Engineering Land Use Application Comments

To: Eric Rutledge, Associate Planner, Planning Department
From: Bob Galati, P.E., City Engineer, Engineering Department
Project: Oregon Street Business Park (LU 21-015)
Date: July 5, 2022

Local Street Connectivity

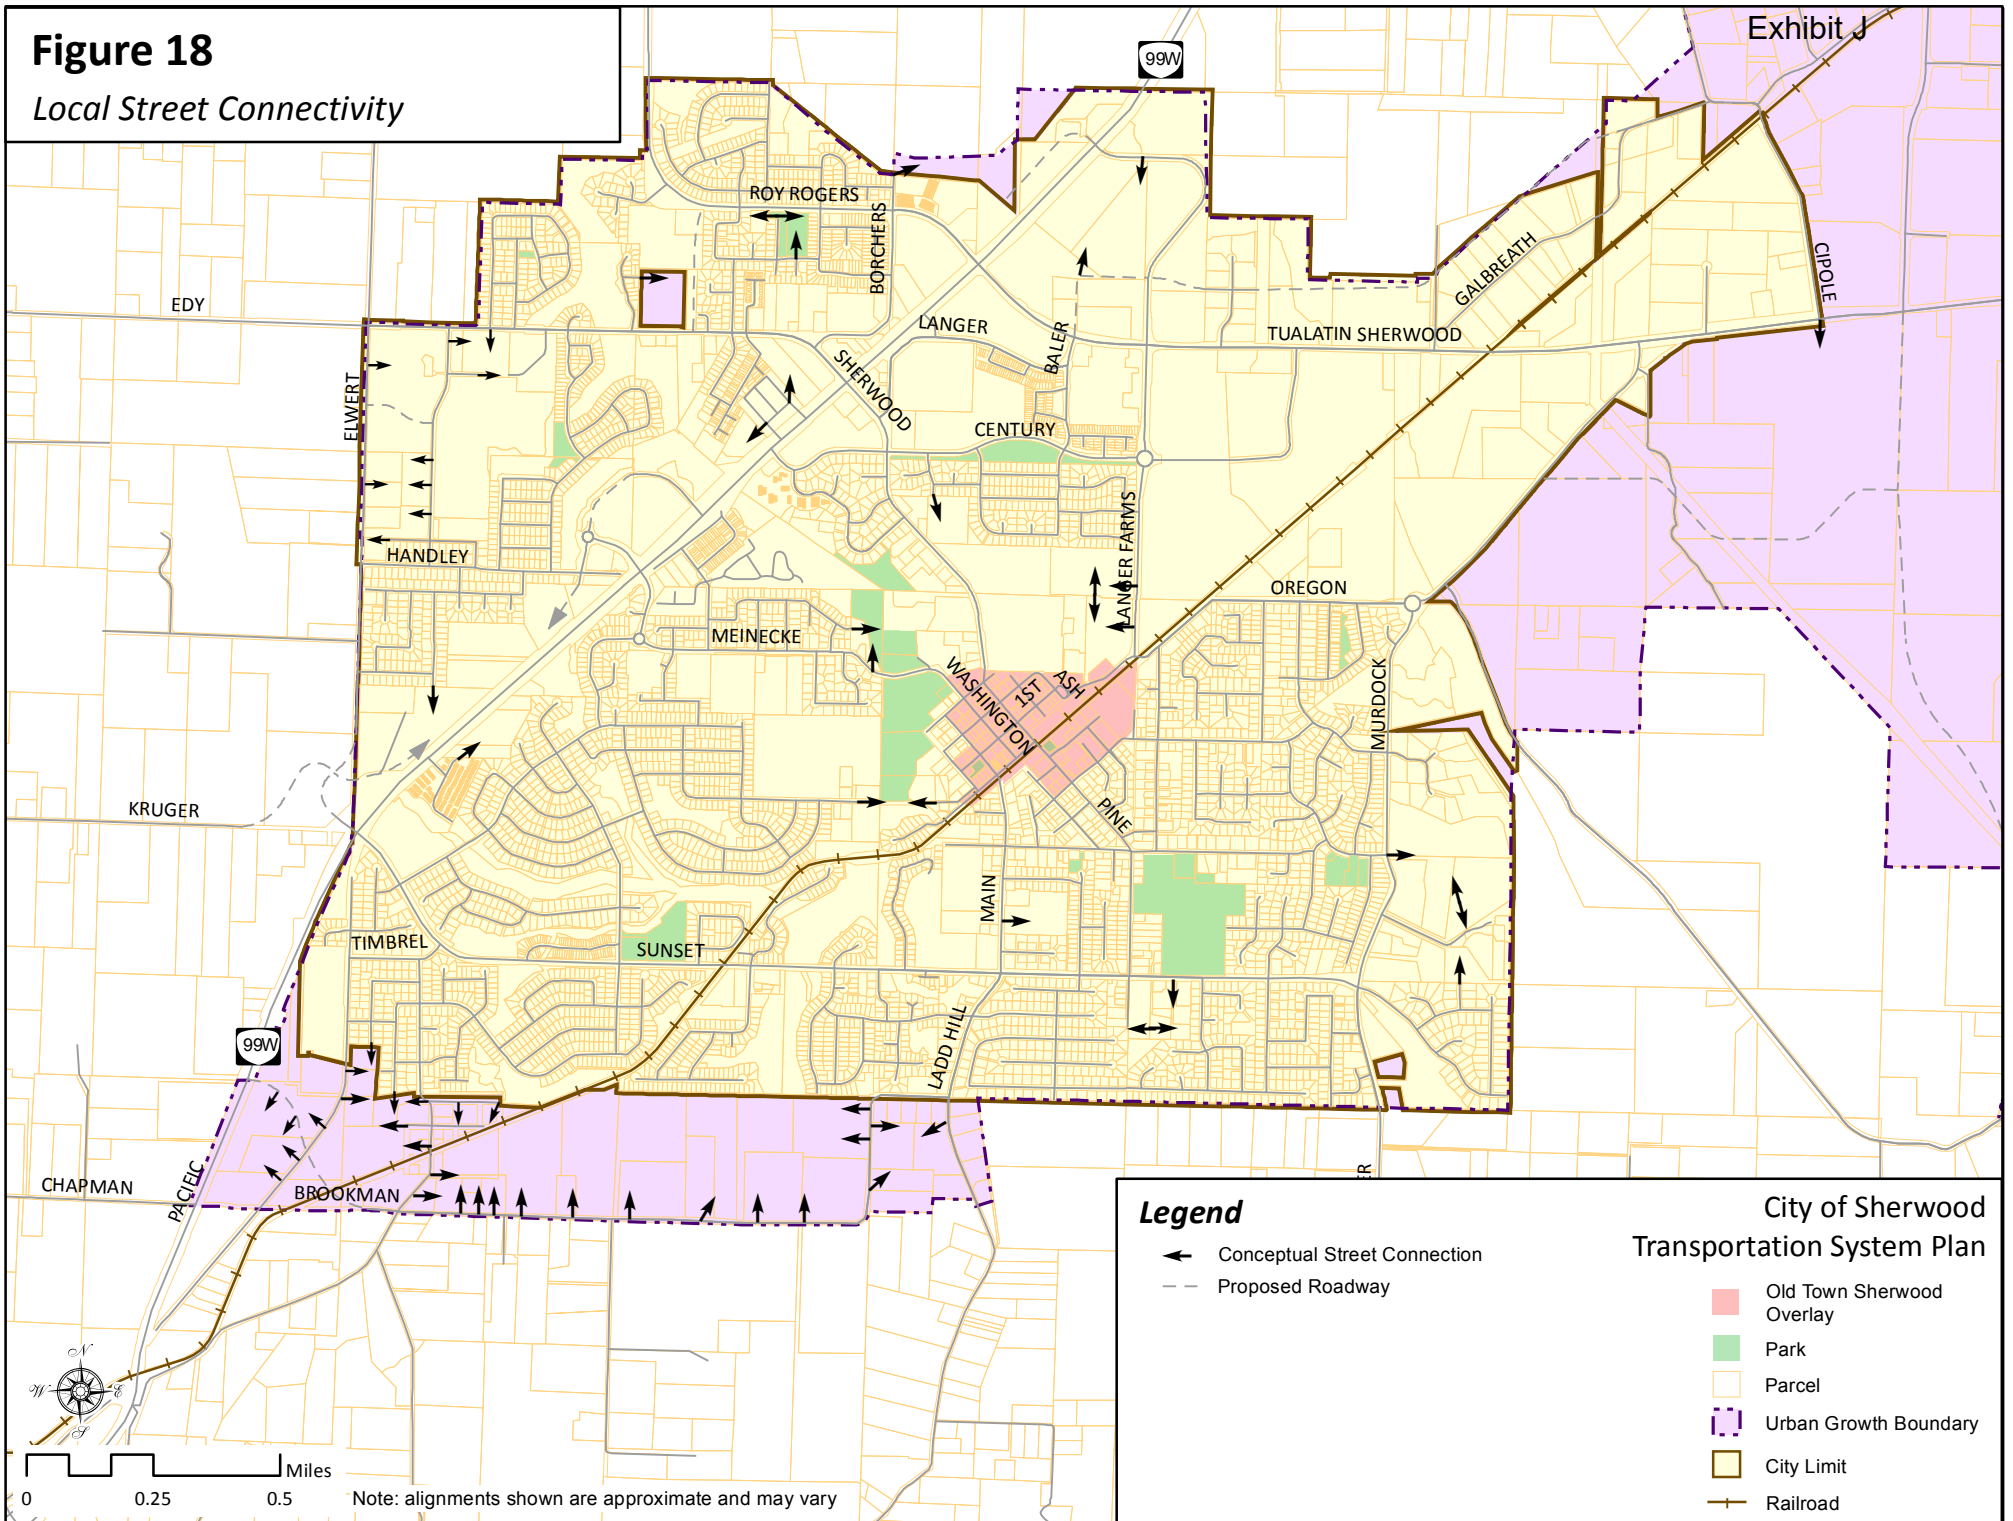
As shown on Figure IV-5 of the TEA Concept plan, an internal connector road (detail number 4) is shown providing local access off Oregon Street to the TEA. Also, as shown on Figure 18 of the Implementation Plan, a local connector road identified as Tonquin Court is clearly presented. The intent of this road connection is to provide for

ACCESS DIAGRAMS

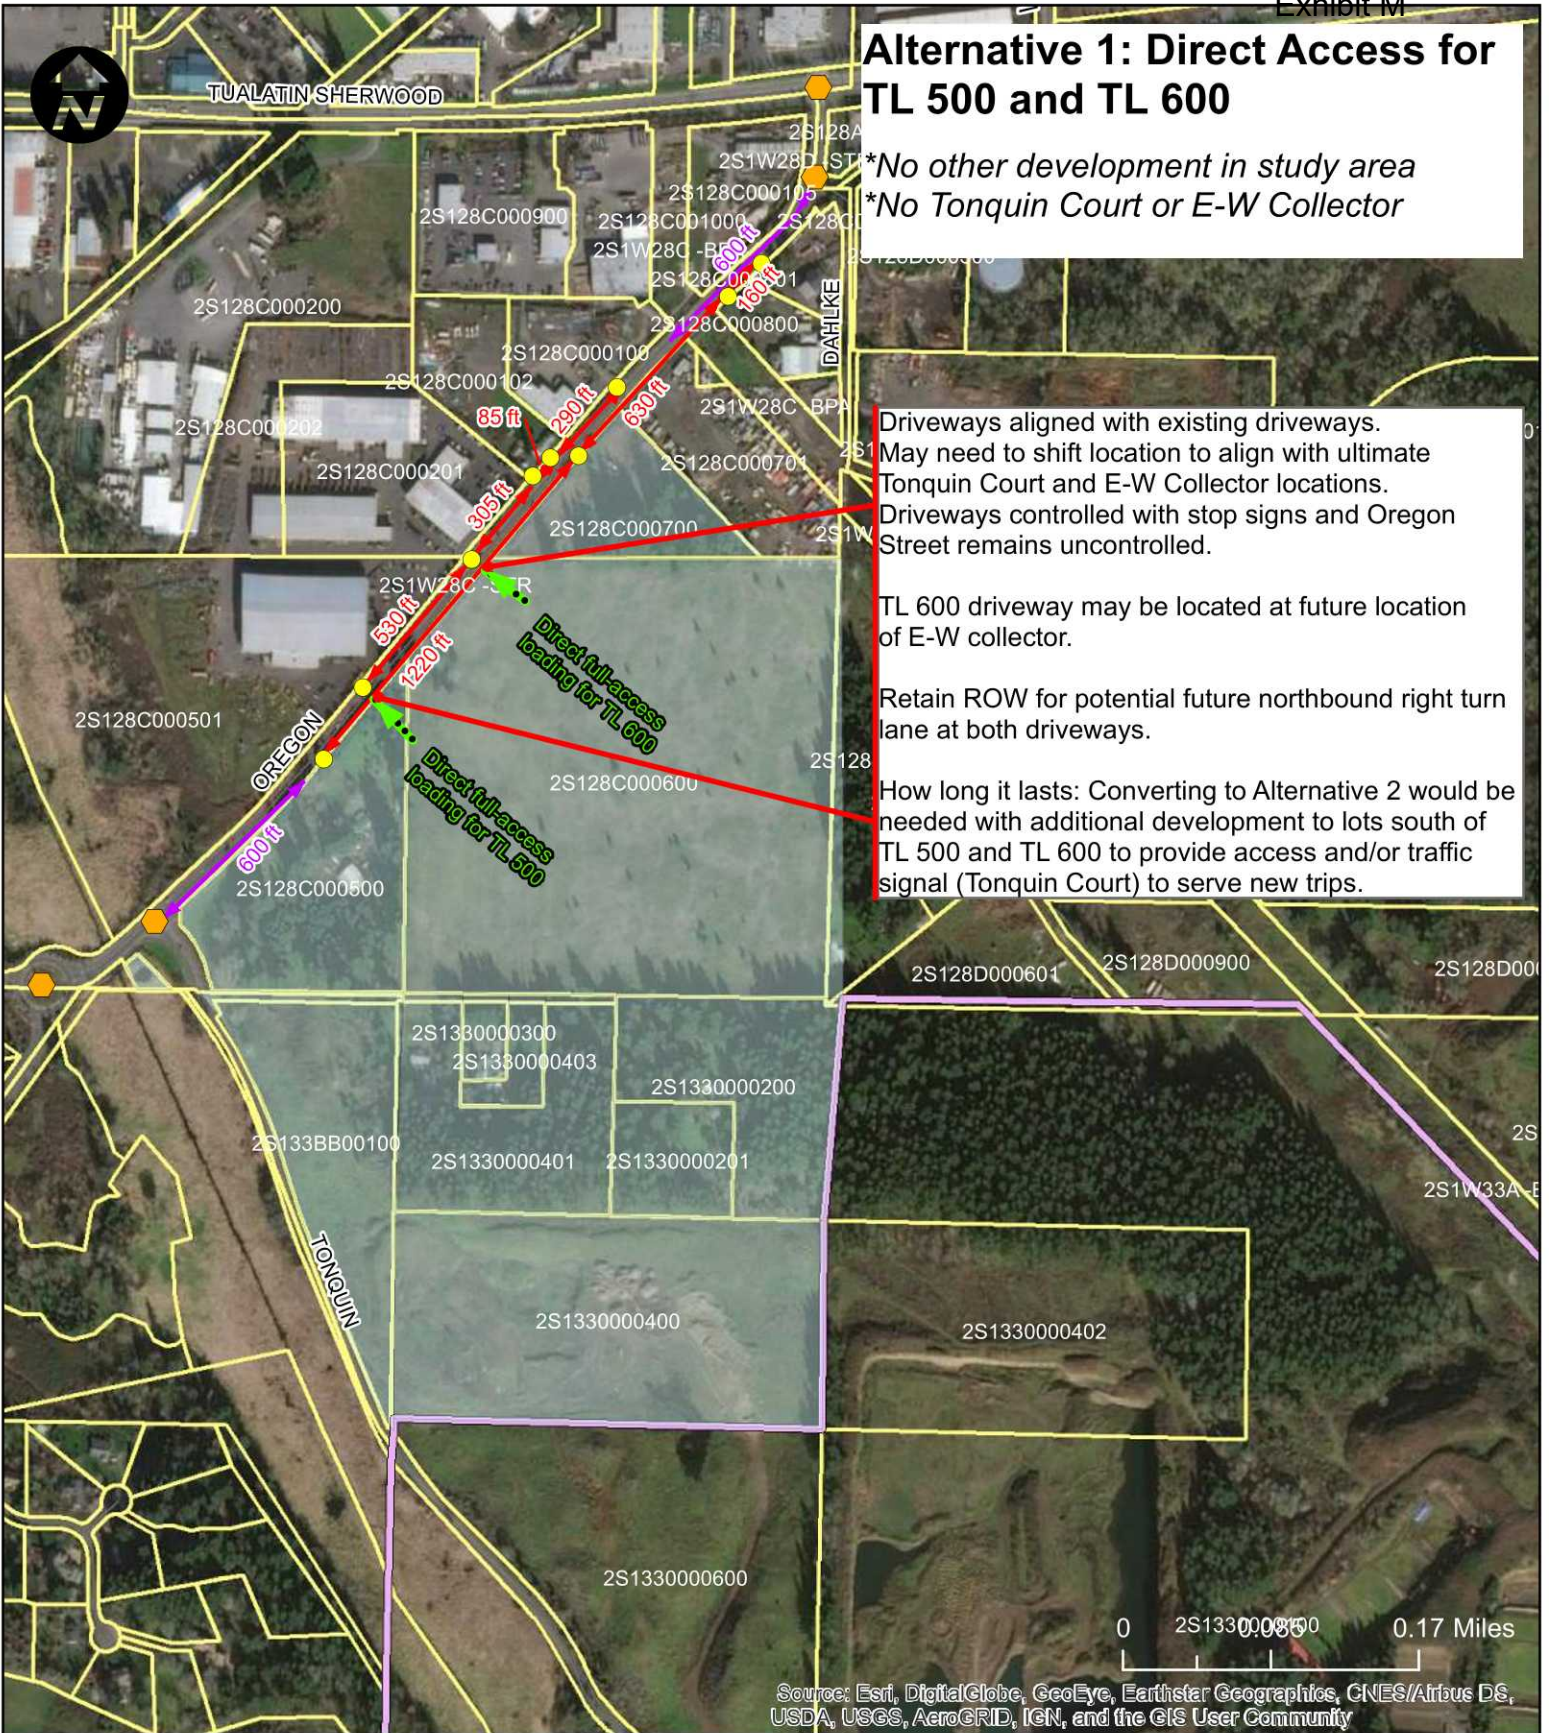
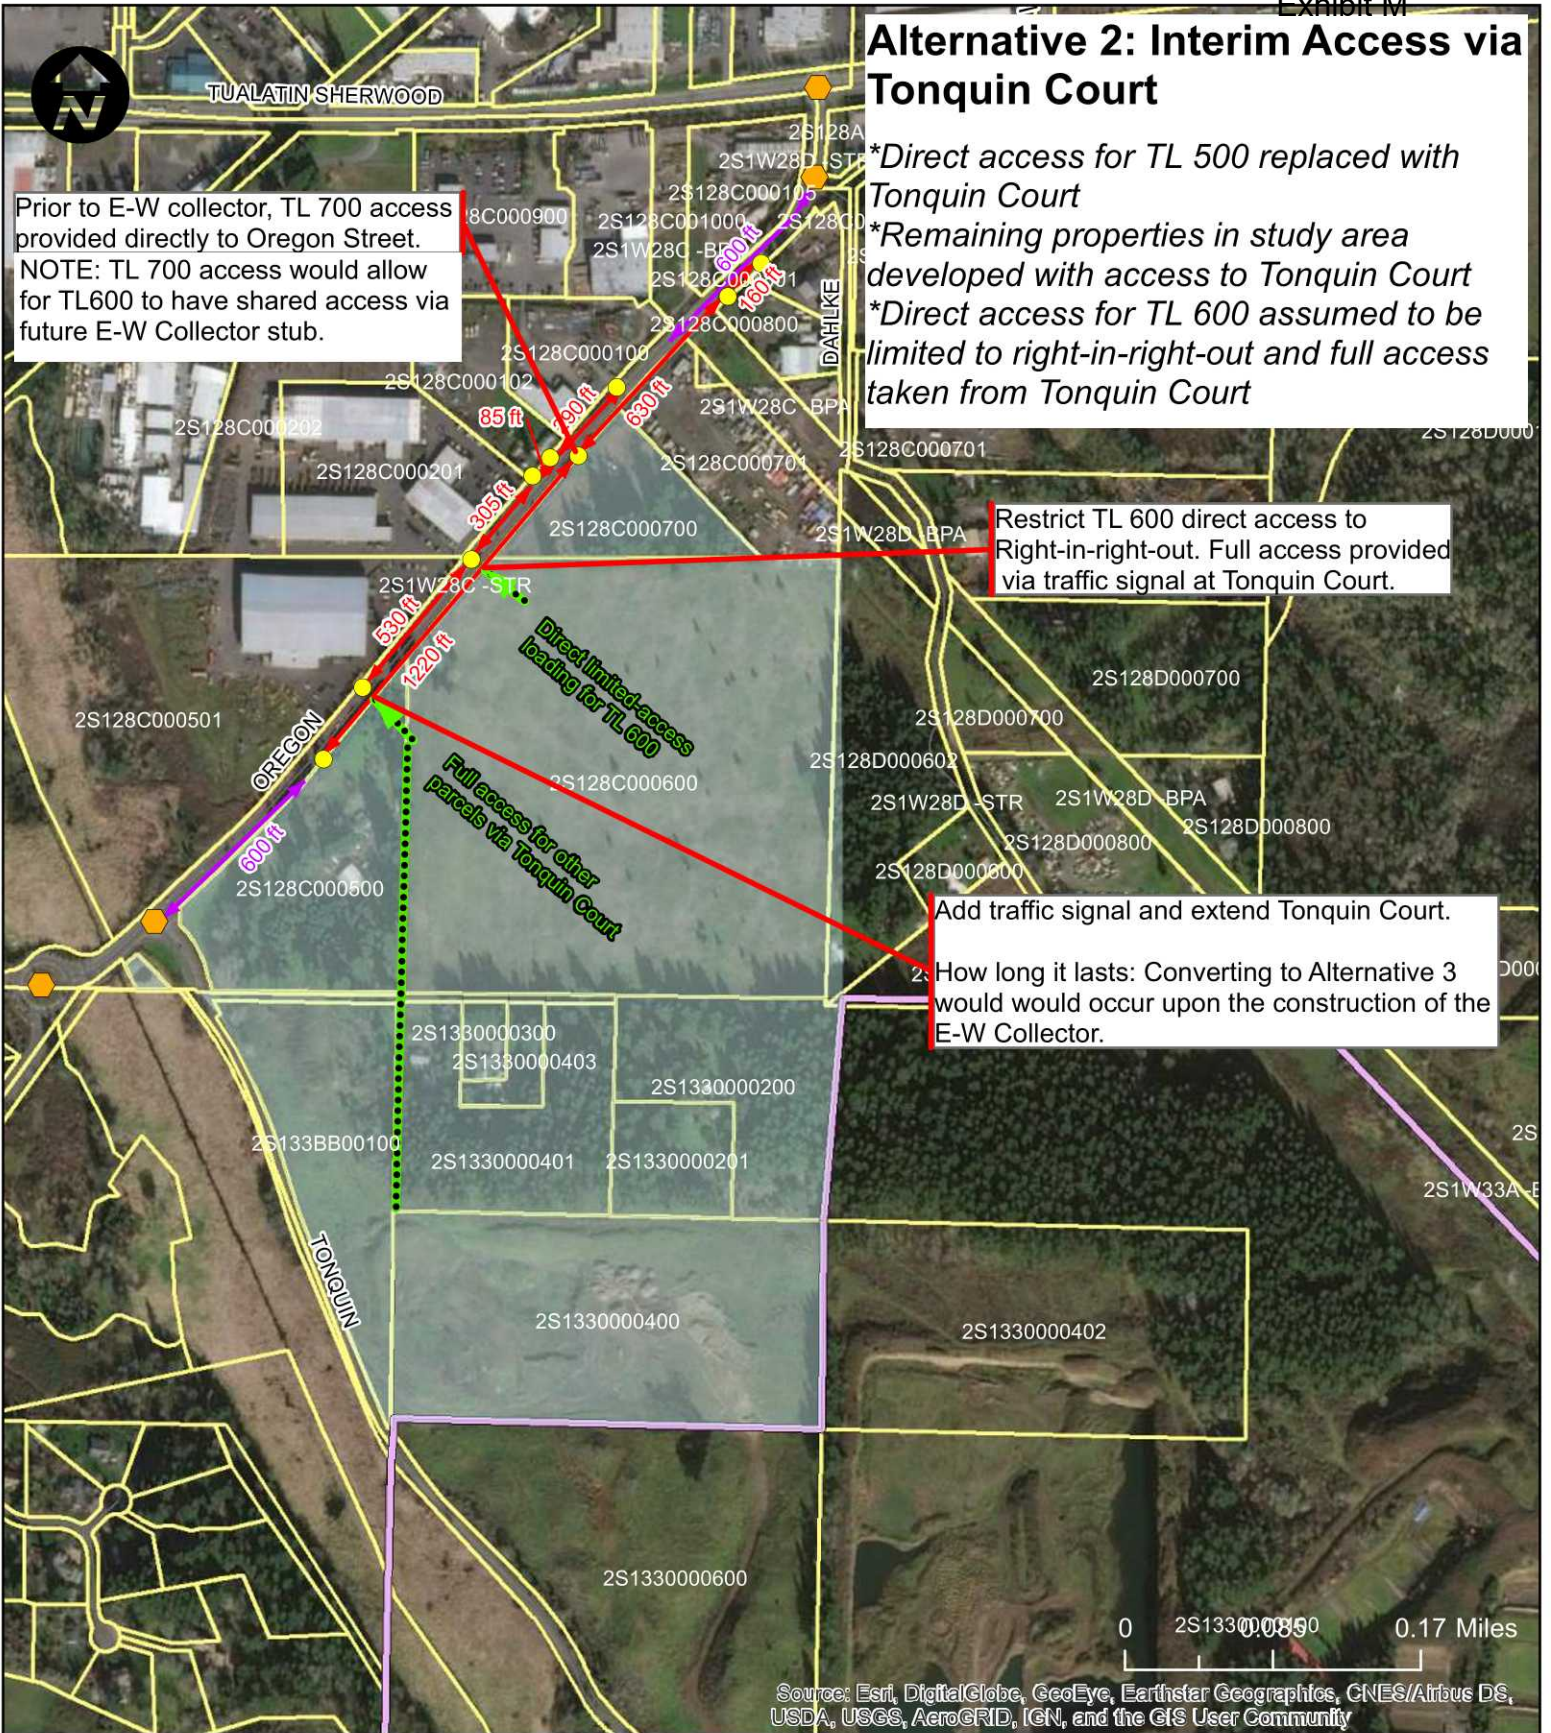
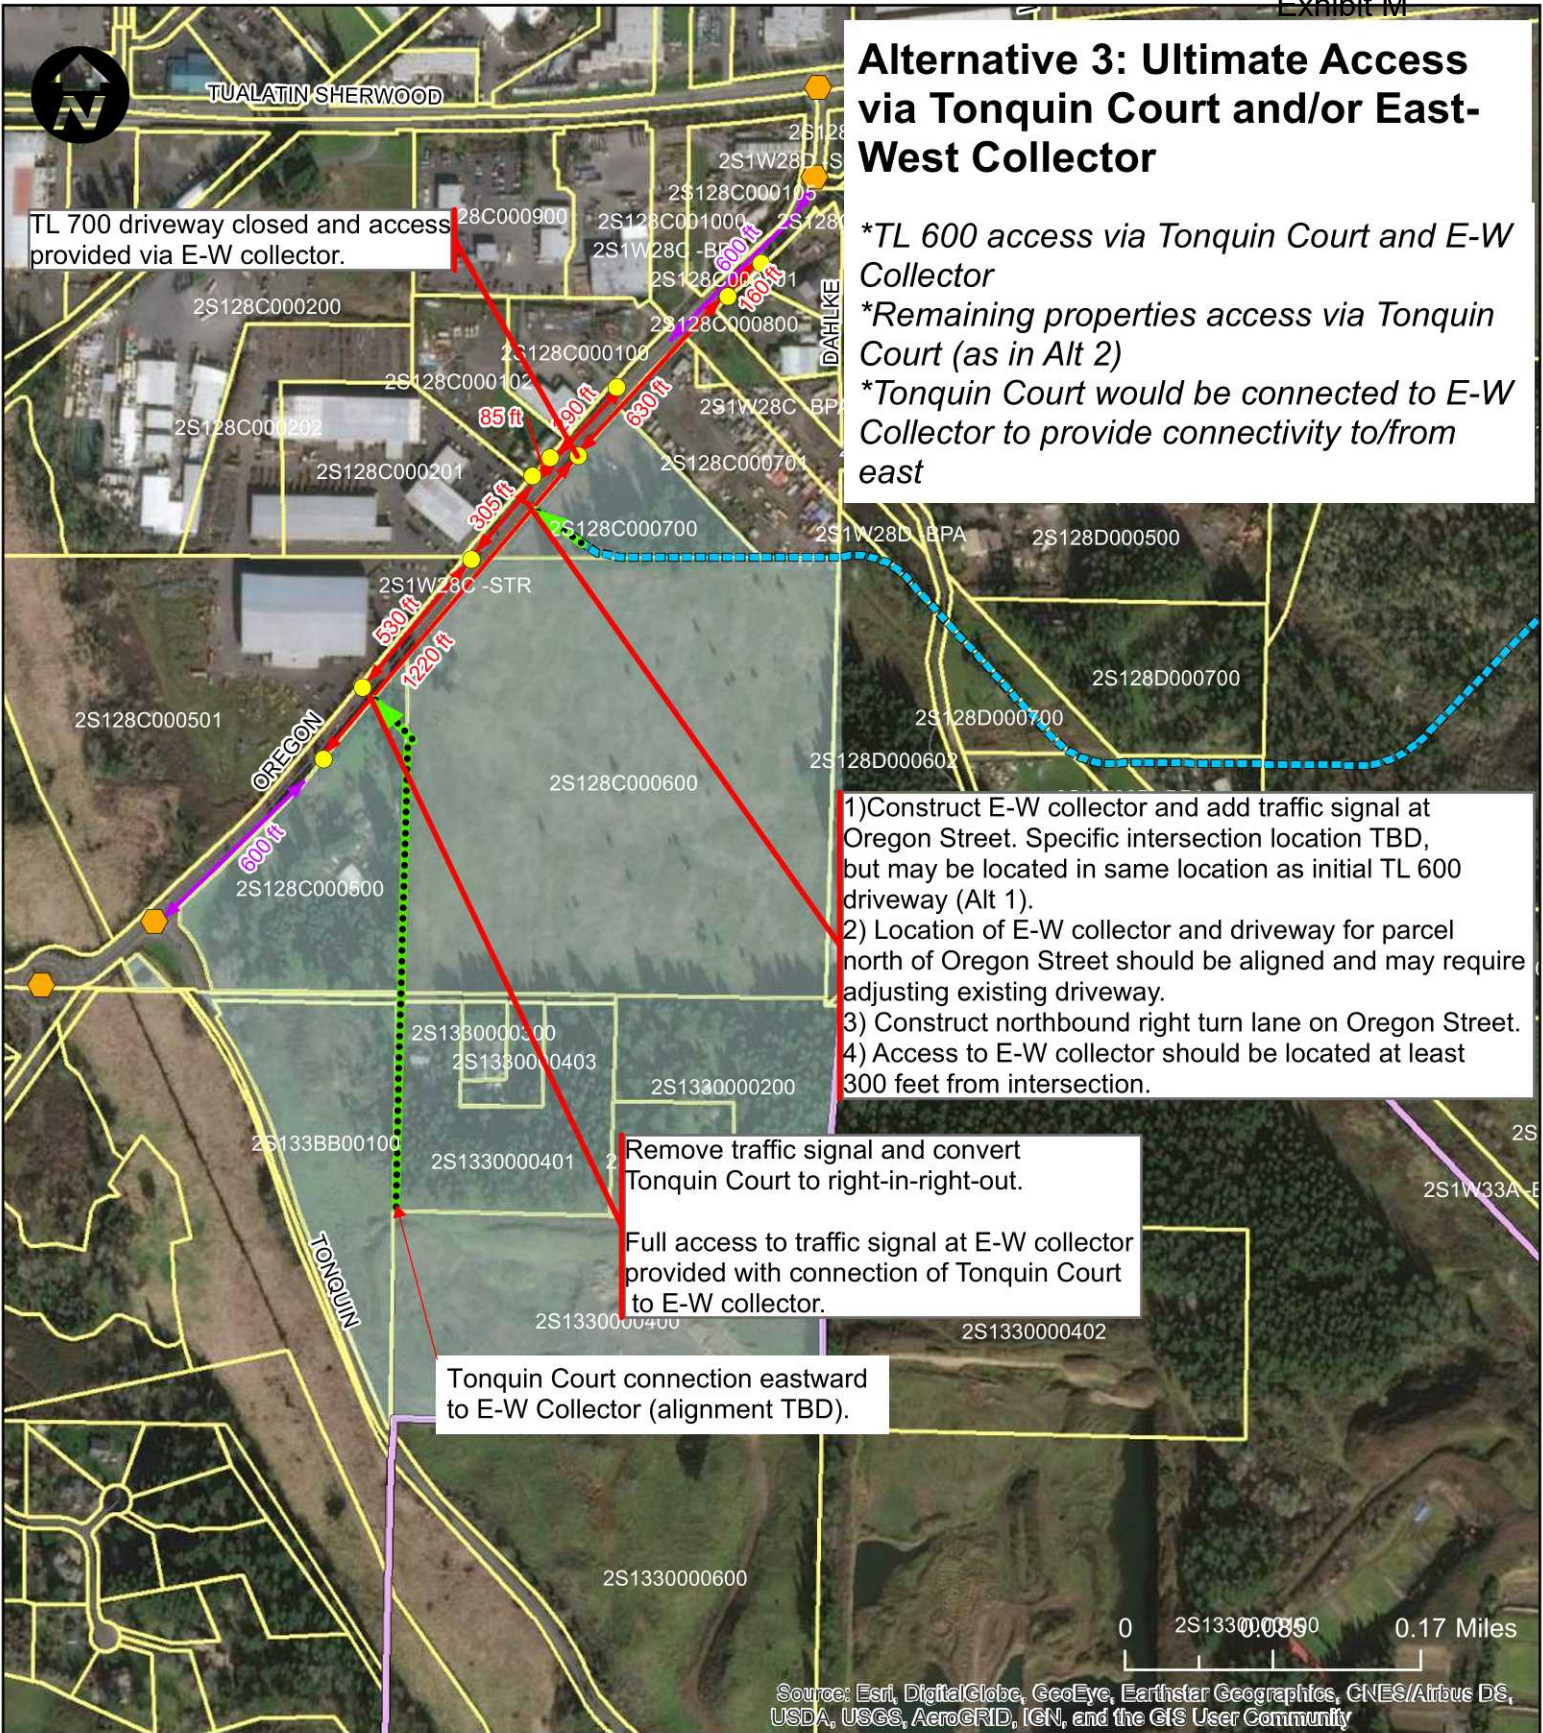
- 3) Alternative 3 – ultimate access configuration will meet WACO access spacing requirements and would be dependent on the completion of the Ice Age Drive collector road. This impact may change the Tonquin Court intersection configuration from a signalized intersection into a restricted right-in/right-out configuration. At a minimum, a right turn lane is anticipated along the eastbound lane of Oregon Street for this intersection under the ultimate access configuration.
